Final Environmental Impact Statement for the White Pine Energy Station Project

Volume 4
Appendixes R through U

- R Responses to Federal Comments on the DEIS
- S Responses to State and Local Comments on the DEIS
- T Responses to Group and Organization Comments on the DEIS
- U Responses to Individual's Comments on the DEIS

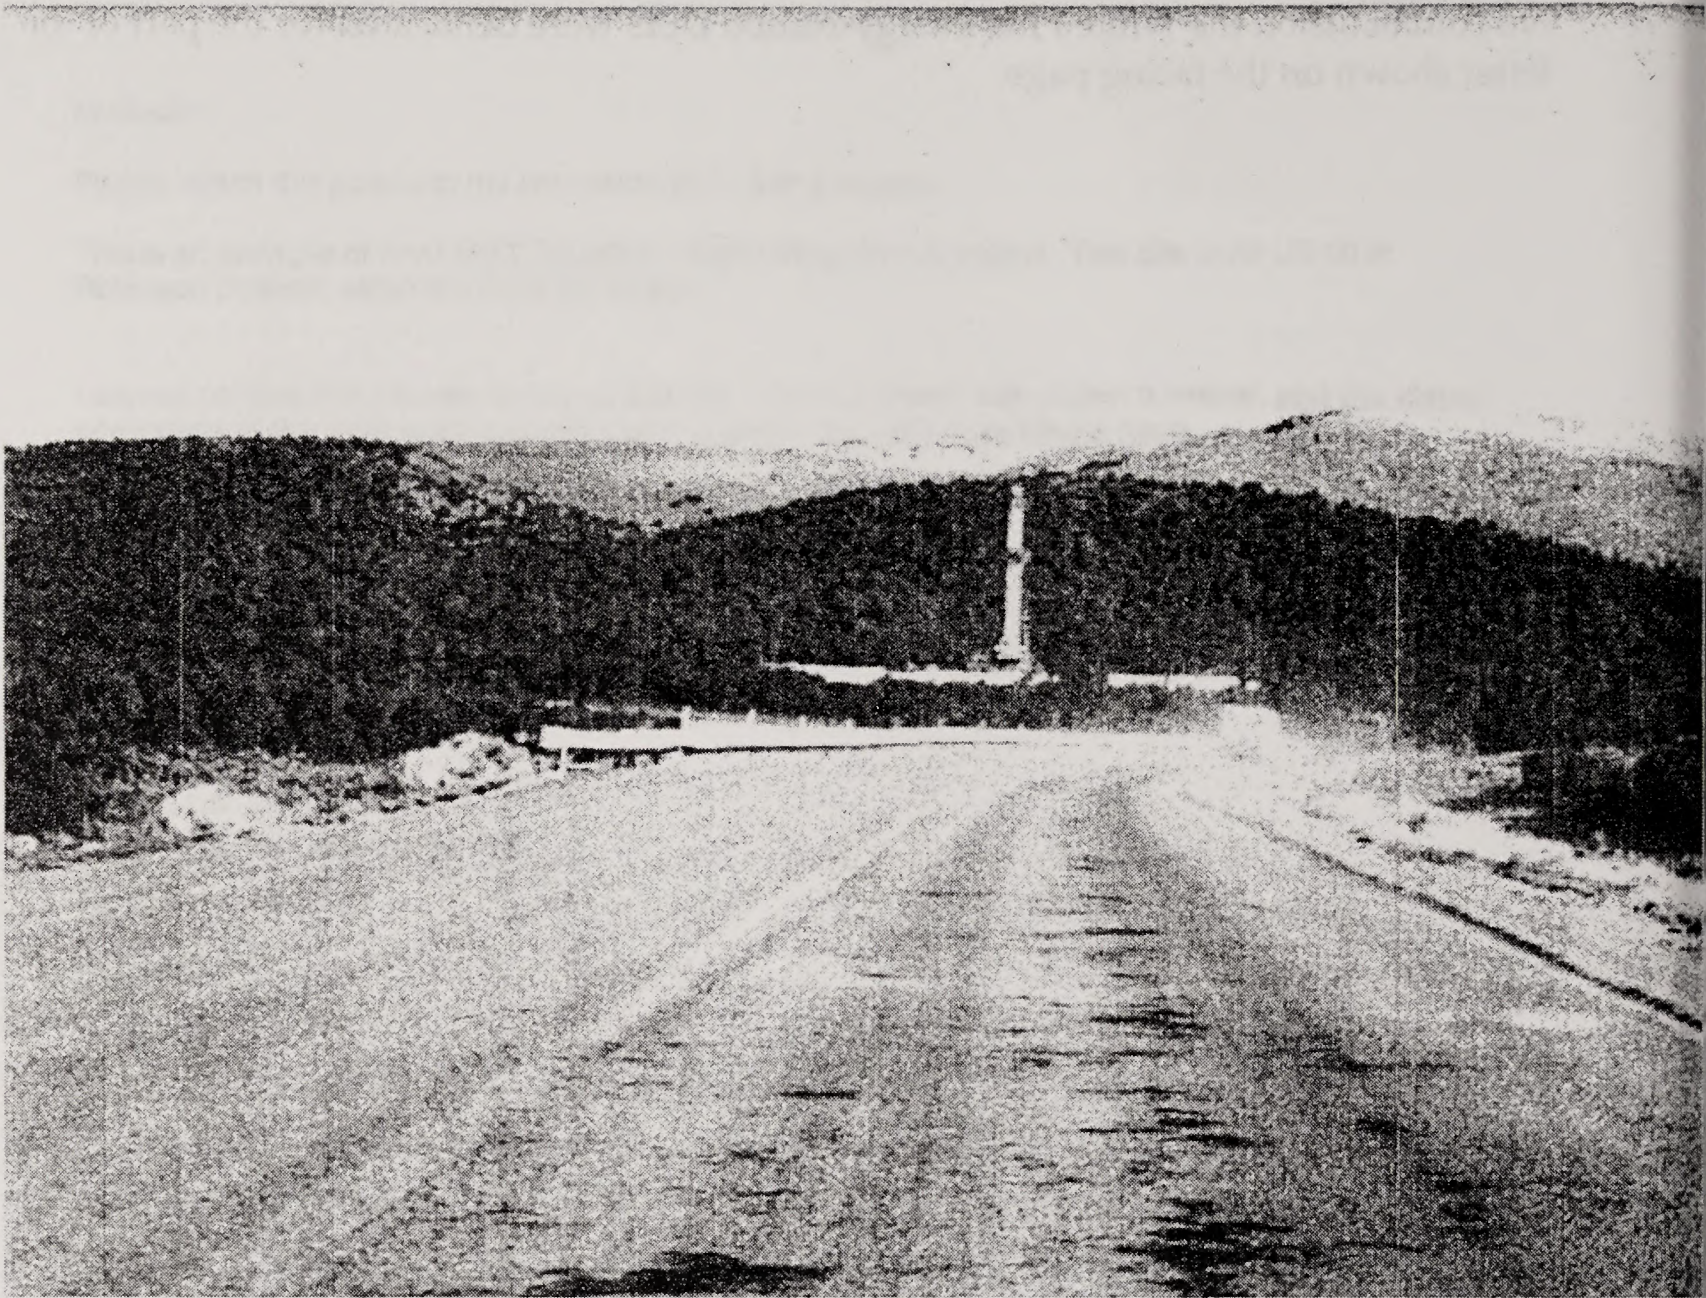
This is an example of what **NOT TO DO** to effectively screen a project. This site is off US 50 at Robinson Summit, within the BLM Ely District.

I am not positive that this site is on public lands. This is a brand new project however, **and the visual screening of the built environment was not even remotely considered here.**
